### Public Comments on the Draft GSP on Dec 11 2021

**Re: Public Comment Letter for Turlock Subbasin Draft GSP**

## Specific Comments on the Turlock Subbasin Draft Groundwater Sustainability Plan

**Re: Comments on the Turlock Subbasin Groundwater Sustainability Plan (GSP).**

**Figure 1 - Representative Monitoring Network for Groundwater Levels Relative to Domestic Wells, DACs, and Public Water Systems West and East Turlock Subbasin GSA**

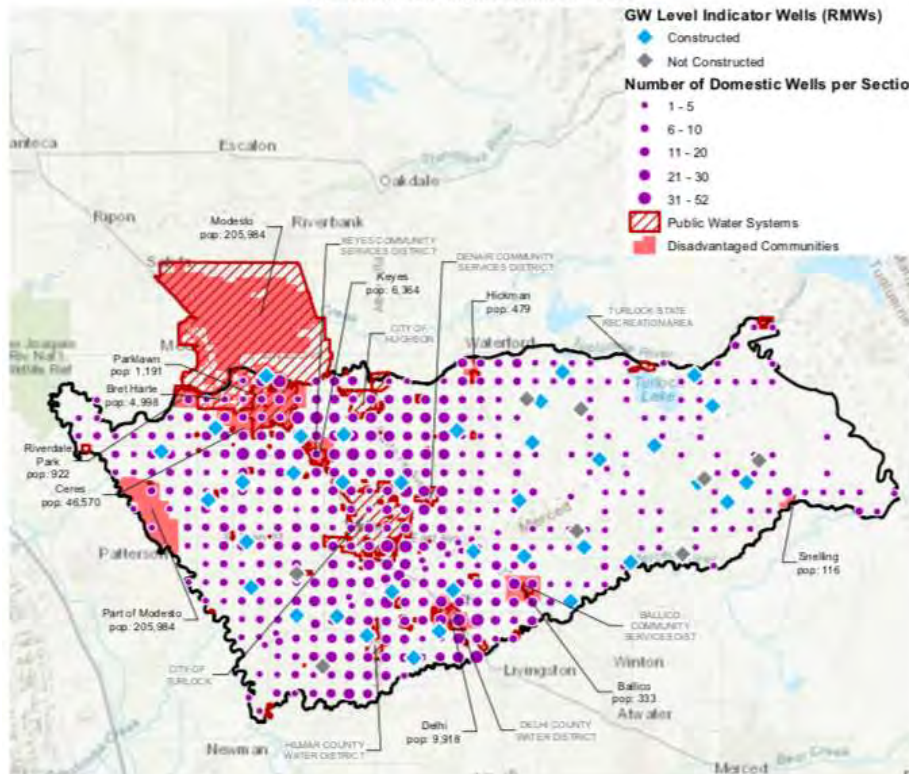
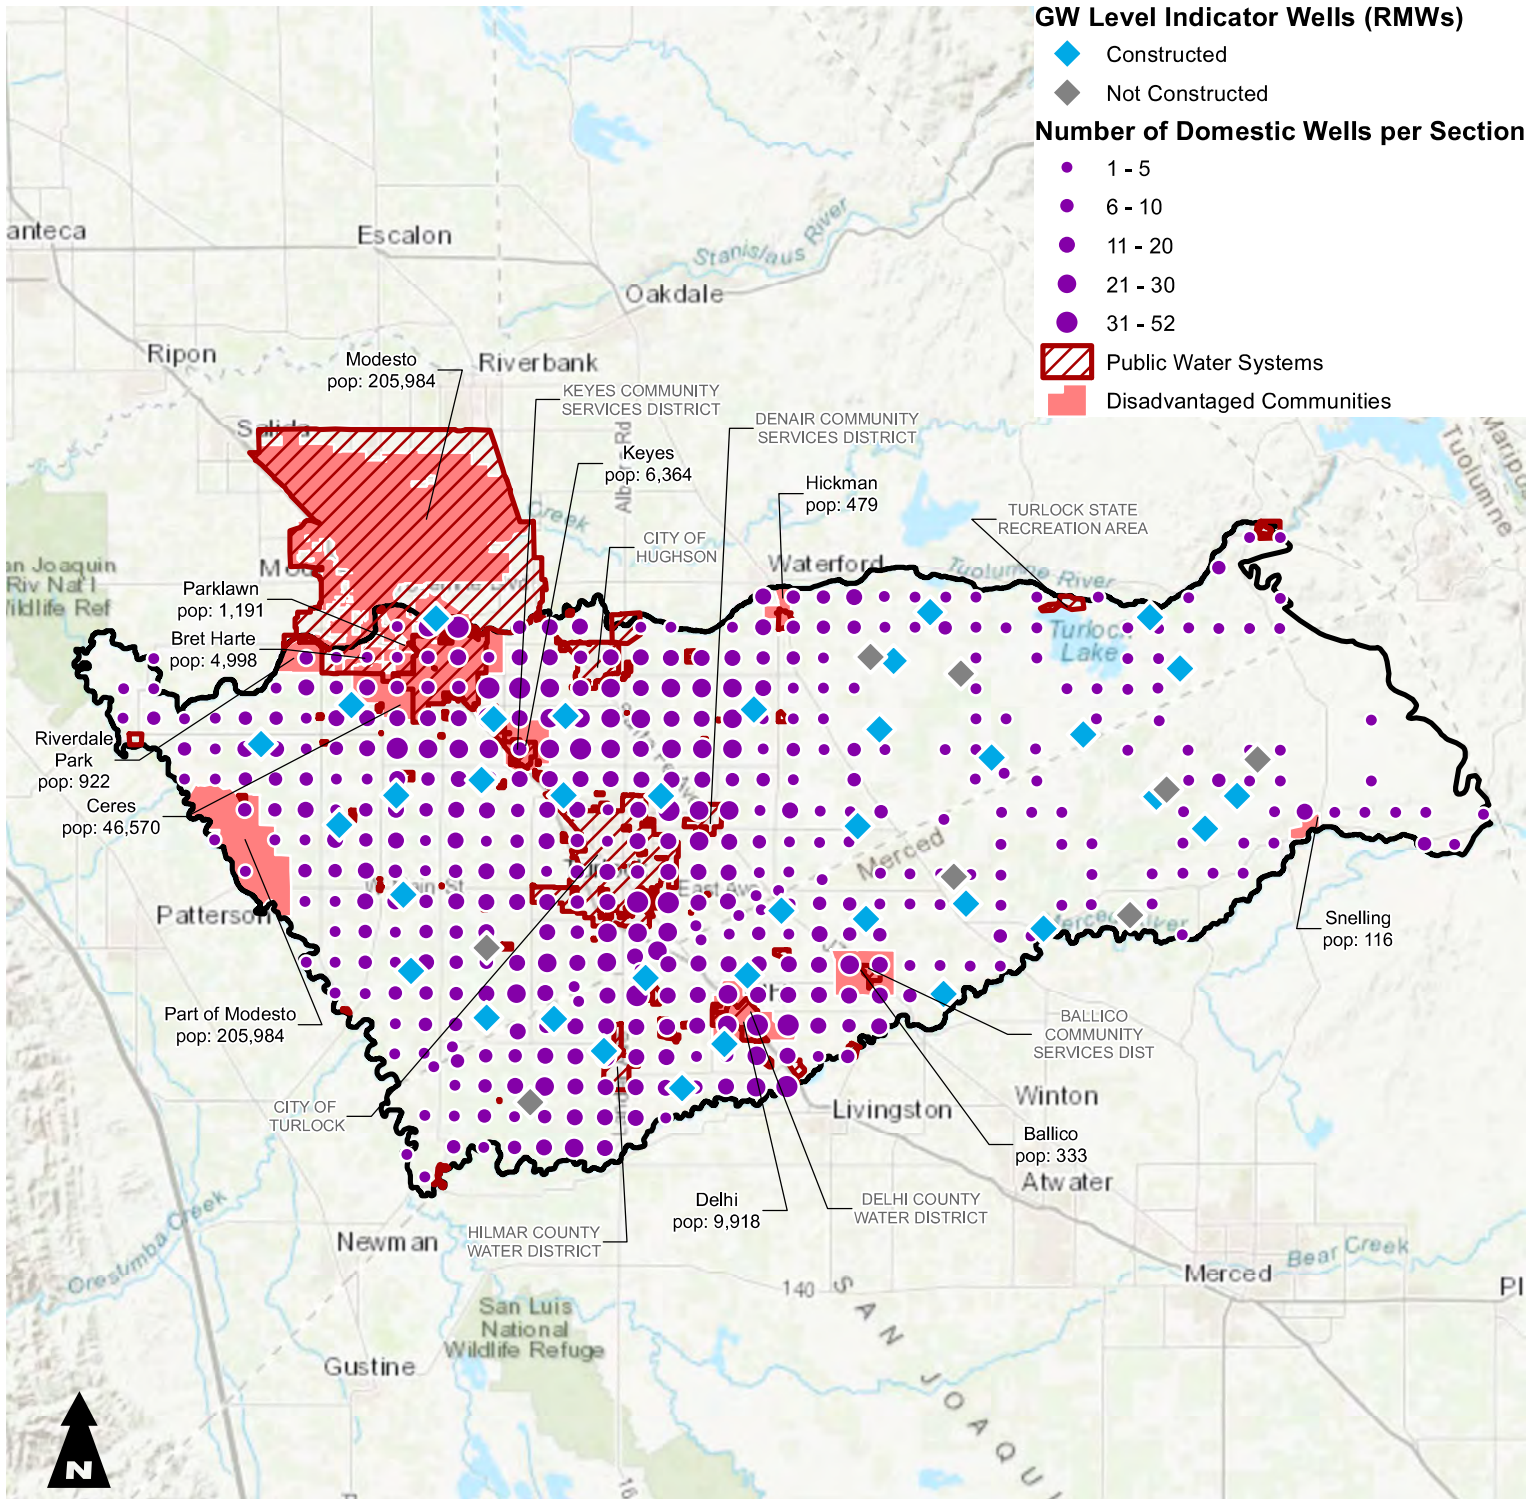
As shown in Figure 1 of the attached Focused Technical Analysis, there are notable gaps in coverage of the water level network in several areas that contain a substantial number of domestic well users and small public water systems. Of the approximately 4,300 identified domestic wells in the Subbasin, approximately 2,500, or 57%, are located more than 1.5 miles from a water level RMW. In particular, domestic well users and small public water systems located 1) along the northern portion of the Subbasin, including the communities of Hughson, Ceres, Hickman, Bret Harte, Parklawn, and southern Modesto (most of which are DACs), 2) along the southern Subbasin boundary, including those surrounding Ballico, Delhi, and Snelling, and 3) a significant portion of domestic well users surrounding the City of Turlock are beyond the 1.5 mile radius of a water level representative monitoring well.

- **Figure 1** shows the location of key drinking water users as indicated above, along with the proposed water level representative monitoring wells (RMWs) that are identified as being in the Western Upper or Eastern principal aquifers (i.e., excluding those identified as being in the Western Lower aquifer beneath the Corcoran clay), including both existing wells and those that have been proposed for construction, per the draft GSP. As illustrated in Figure 1m there are notable gaps in coverage of the water level network in several areas with a substantial number of domestic well users and small public water systems. Of the approximately 4,300 identified domestic wells in the Subbasin, approximately 2,500, or 57%, are located more than 1.5 miles from a water level RMW. In particular, domestic well users and small public water systems located 1) along the northern portion of the Subbasin, including the communities of Hughson, Ceres, Hickman, Bret Harte, Parklawn, and southern Modesto (most of which are DACs), 2) along the southern Subbasin boundary, including those surrounding Ballico, Delhi, and Snelling, and 3) a significant portion of domestic well users surrounding the City of Turlock. **Therefore, it is recommended that additional water level RMWs be established proximate to these communities and domestic wells, in order to be protective of drinking water beneficial users across the Subbasin.**

**Figure 4 - Monitoring Network for Groundwater Quality Relative to Domestic Wells, DACs, and Public Water Systems West and Turlock Subbasin GSA**

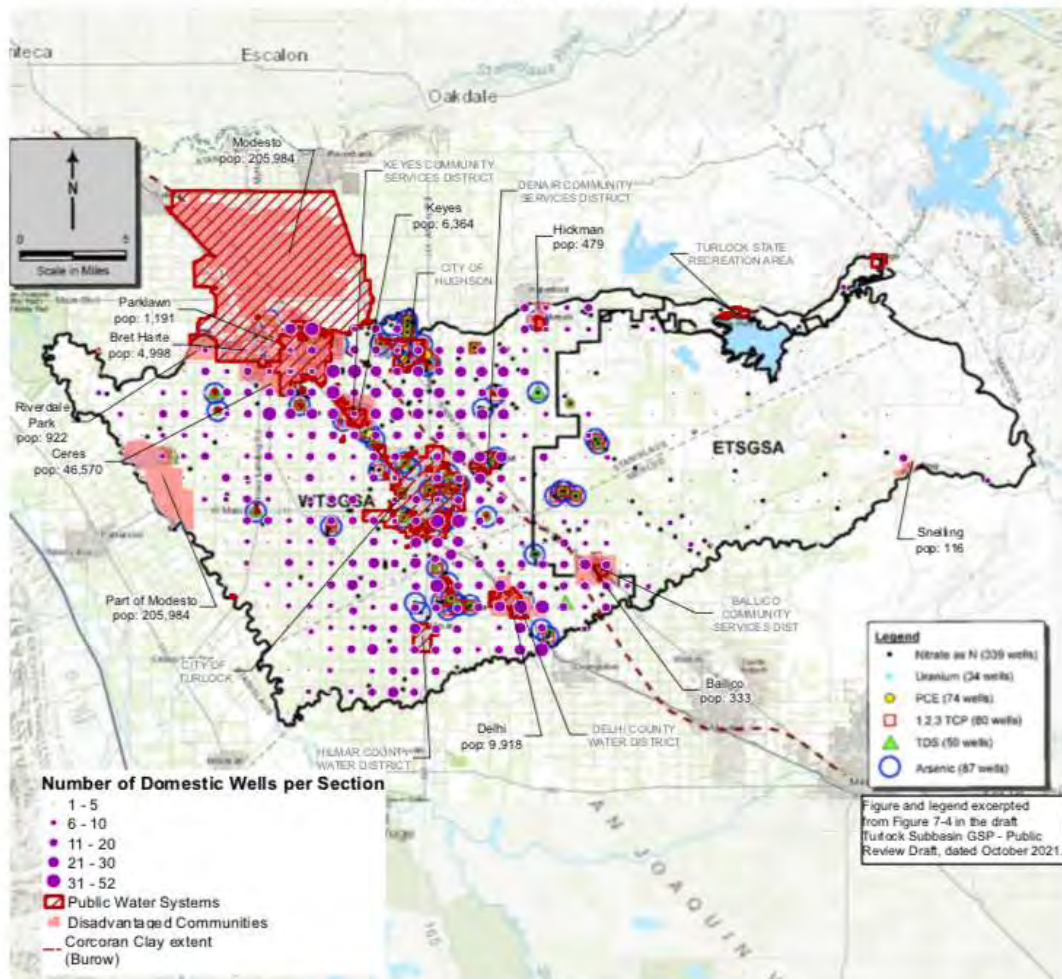
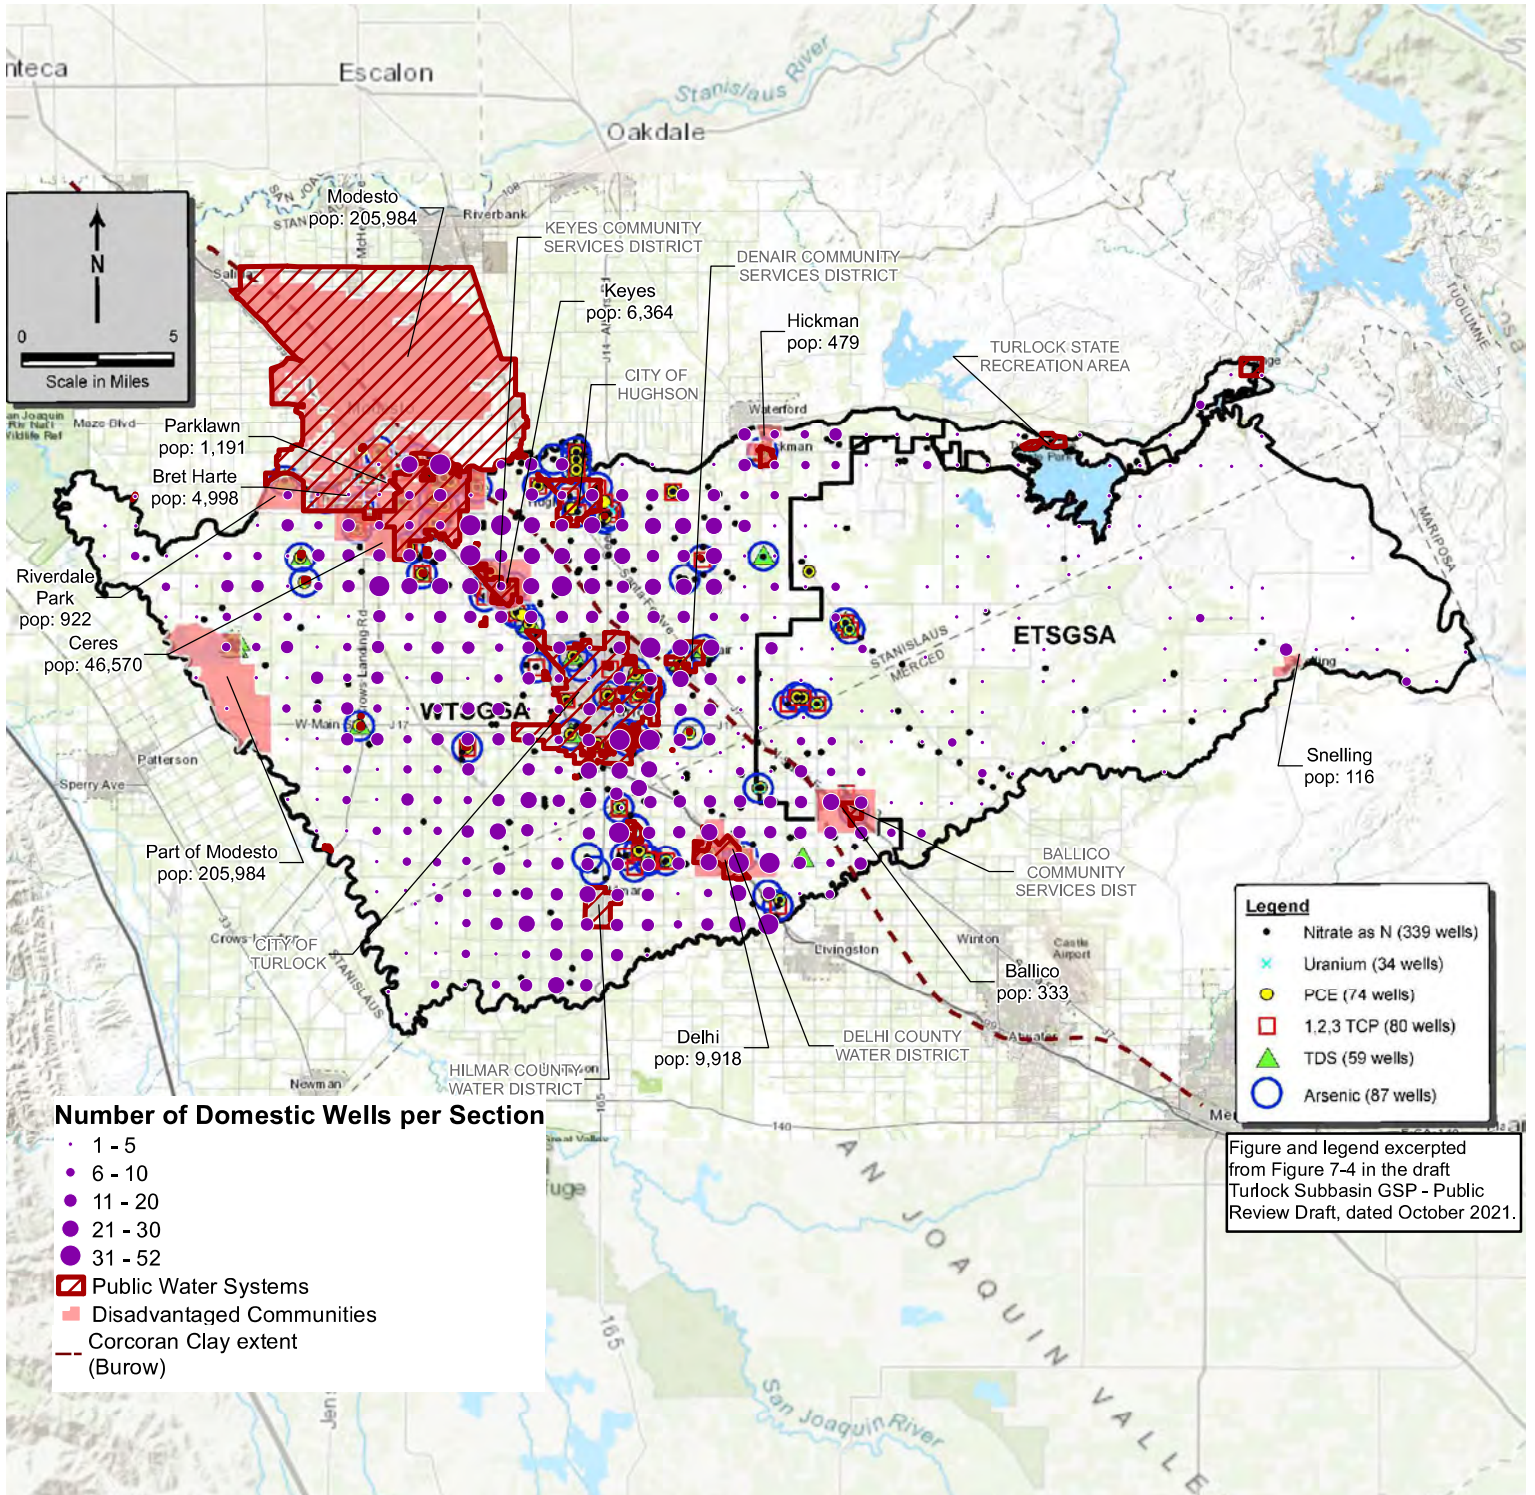
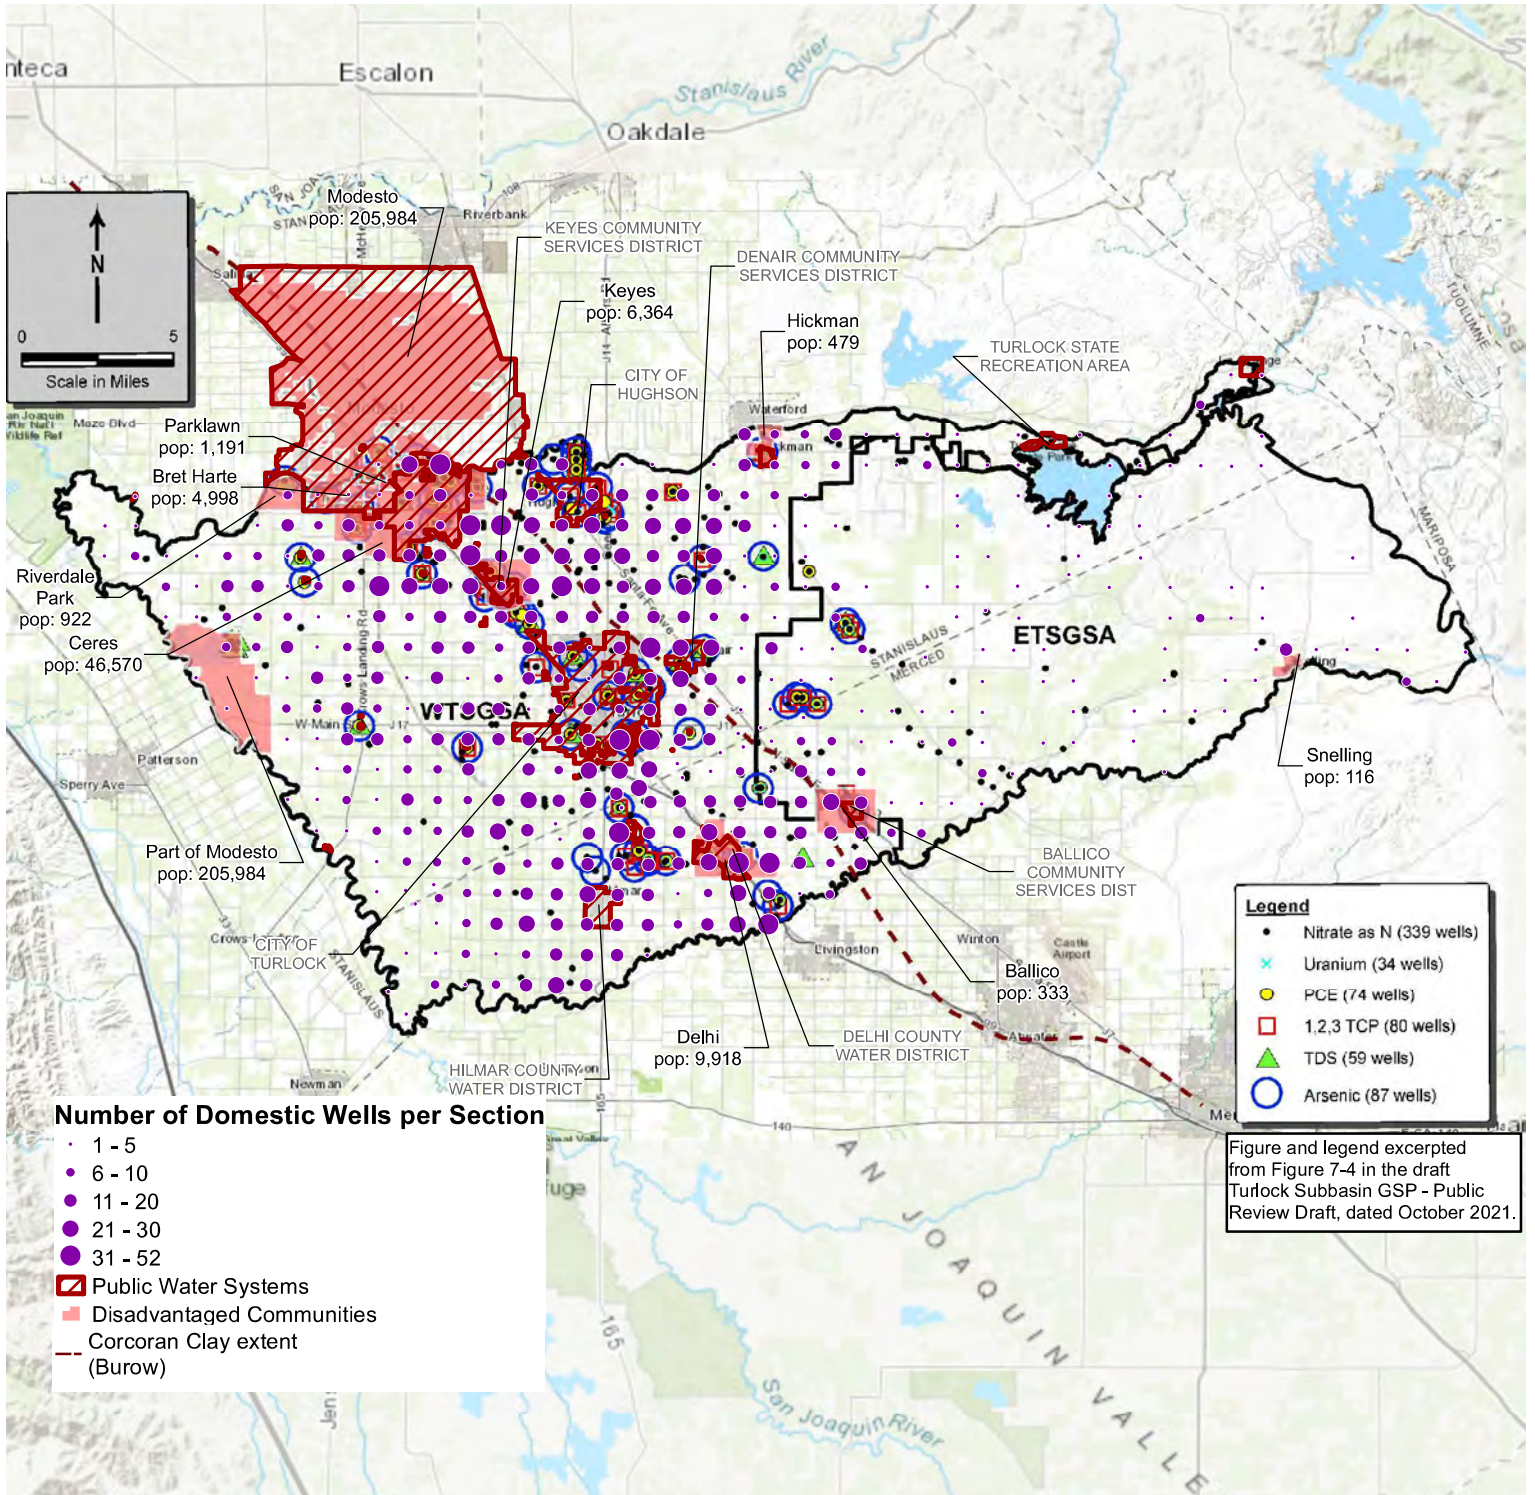
First, as shown in Figure 4 in the attached Focused Technical Analysis, monitoring wells are lacking in many areas with high concentrations of domestic wells and disadvantaged communities in the subbasin. The GSAs must address these data gaps and establish a clear plan for adding monitoring sites to detect impacts to these most vulnerable drinking water users.

Second, the GSAs’ planned approach for monitoring water quality will render inconsistent results and prevent the GSAs from progressively or effectively monitoring impacts and progress towards plan goals. The GSAs have not specifically defined a SGMA monitoring network for degraded water quality and will rely entirely on existing water quality monitoring programs in place throughout the Subbasin (including GAMA, Geotracker, CV-SALTS, and the Nitrate Control Program). The draft GSP also notes that “the monitoring network will vary from year-to-year based on regulatory requirements from each water quality program.” Therefore, the GSAs will not be able to independently control the availability, frequency, and quality of water quality monitoring data used to evaluate SGMA compliance within the Subbasin. This monitoring system is not likely to meet the requirements to “develop a monitoring network capable of collecting sufficient data to demonstrate short-term, seasonal, and long-term trends in groundwater conditions... to demonstrate progress toward achieving measurable objectives

- **Figure 4** shows the locations of water quality RMWs relative to domestic wells, public water systems, and DACs within the Subbasin. As described in Section 7.1.4, the GSAs have not specifically defined a SGMA monitoring network for degraded water quality and will rely entirely on existing water quality monitoring programs in place throughout the Subbasin (including GAMA, Geotracker, CV-SALTS, and the Nitrate Control Program). The draft GSP notes that “the monitoring network will vary from year-to-year based on regulatory requirements from each water quality program.” By outsourcing water quality monitoring to existing programs outside the purview of SGMA regulation, the GSAs will not be able to independently control the availability, frequency, and quality of water quality monitoring data used to evaluate SGMA compliance within the Subbasin and may not meet GSP regulations to “develop a monitoring network capable of collecting sufficient data to demonstrate short-term, seasonal, and long-term trends in groundwater conditions... to demonstrate progress toward achieving measurable objectives described in the Plan, [or] to monitor impacts to the beneficial uses or users of groundwater” (23-CCR §354.34). **Therefore, it is recommended that the GSP explicitly define a set of monitoring**
